VEHICLE SAFETY DEFECT SERVICE BULLETIN

Recall Campaign 08V098000 US Units

Re: Safety Recall – LP Rubber Hose on Refrigerator

Refrigerator Propane Supply Hose Routing & Securement

Figure 1

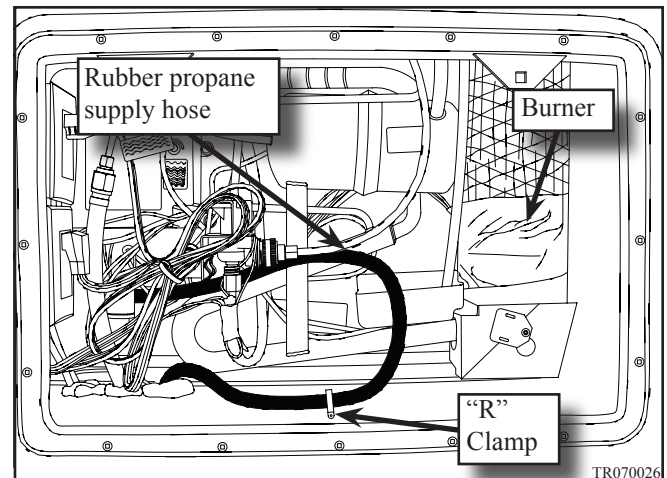
NOTE: If the hose **is** adequately secured, and there is excess hose looped in the refrigerator cabinet and the hose shows no signs of damage or excessive wear (*Figure 1*), the inspection is complete and no further steps are necessary. If the hose **is not** adequately secured, and there is excessive hose looped in the refrigerator cabinet (*Figure 2*), or if the hose shows signs of damage or excessive wear, proceed to the **Repair Procedures** section.

Figure 3

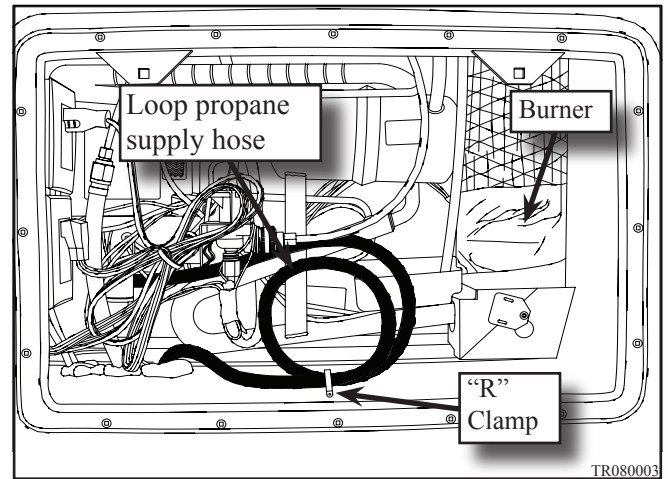
Note: If the propane supply hose has too much excess hose to safely secure, coils may be looped into the line and secured to the cabinet floor with a rubber coated "R" clamp (*Figure 3*).

1. If no damage is present, gently pull the excess slack from the propane supply hose and use a rubber coated "R" clamp to secure it to the cabinet floor as far from the burner as possible.
